Product Change Notification

PCN-IFC-8202-2022

Business Unit	Product Line Code	Type of Change	Action	Date of Issue
IFC - Industrial Field Connectivity	BF7	Product Change Notification	Notify Distributors and Field	8/29/2022

Description for Product Change Notification

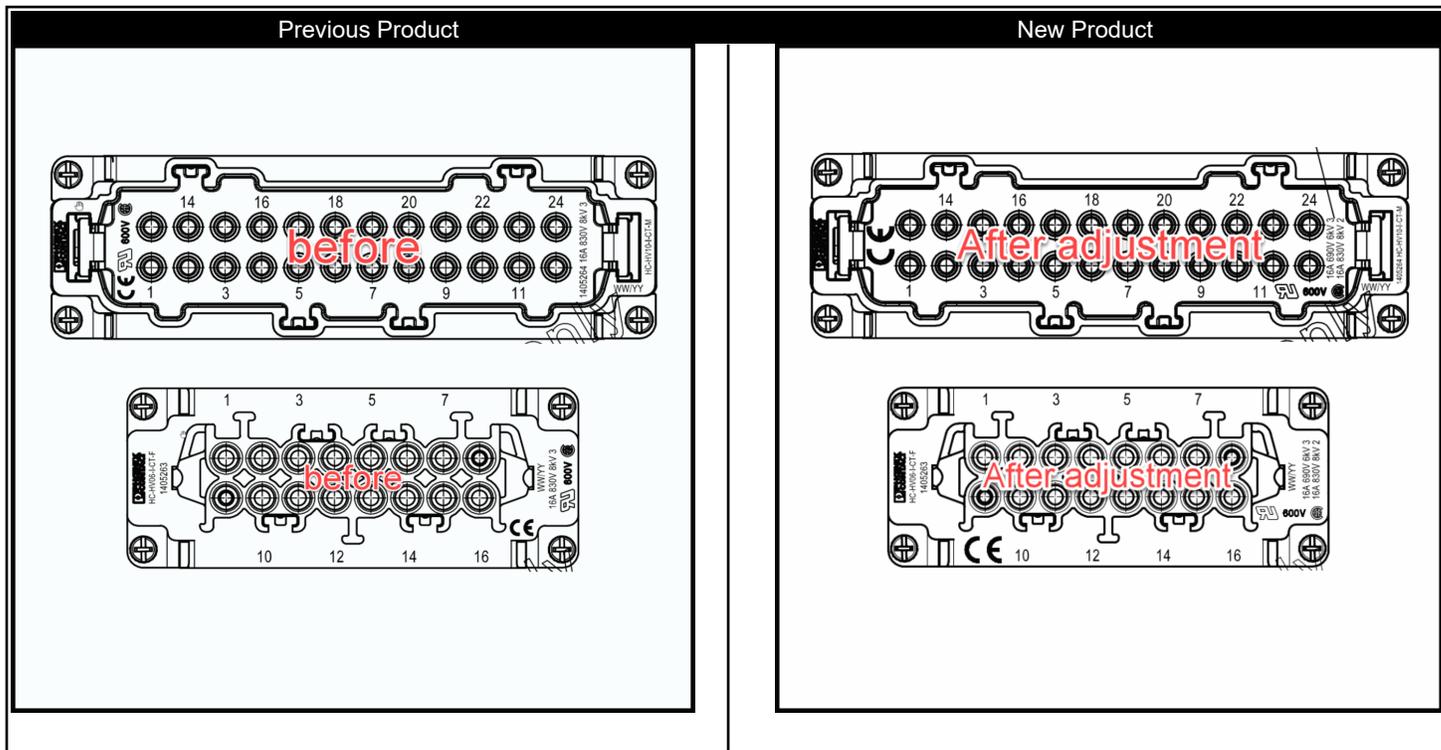
In order to make it easier to identify the differentiation between voltage ratings for different pollution degrees, the documentation and product markings have been revised to include the voltages for multiple pollution degrees. This will help clarify the actual voltage rating for different environments.
